PREVOST

WARRANTY BULLETIN

DATE: September 1998 SECTION: 12

SUBJECT: INSTALLATION OF A PARKING BRAKE BUTTON PROTECTIVE COVER

FIGURE 2: PARKING BRAKE BUTTON PROTECTIVE COVER

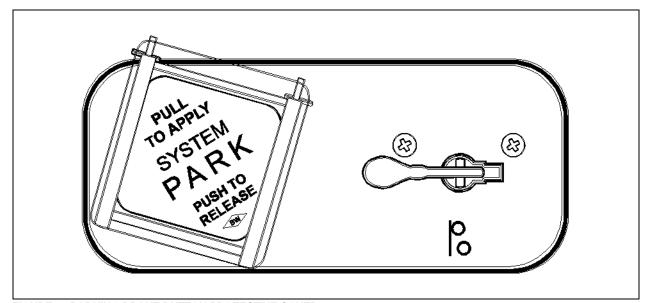
Install parking brake button inside protective cover (Prévost part #391727), indexing them so that roll pin can be installed. Secure button by installing the roll pin. See figure 2.

Note: The operation of the parking brake will be modified by the addition of the protective cover. To apply parking brake, lift protective cover c/w button; to release parking brake, open protective cover and push yellow button.
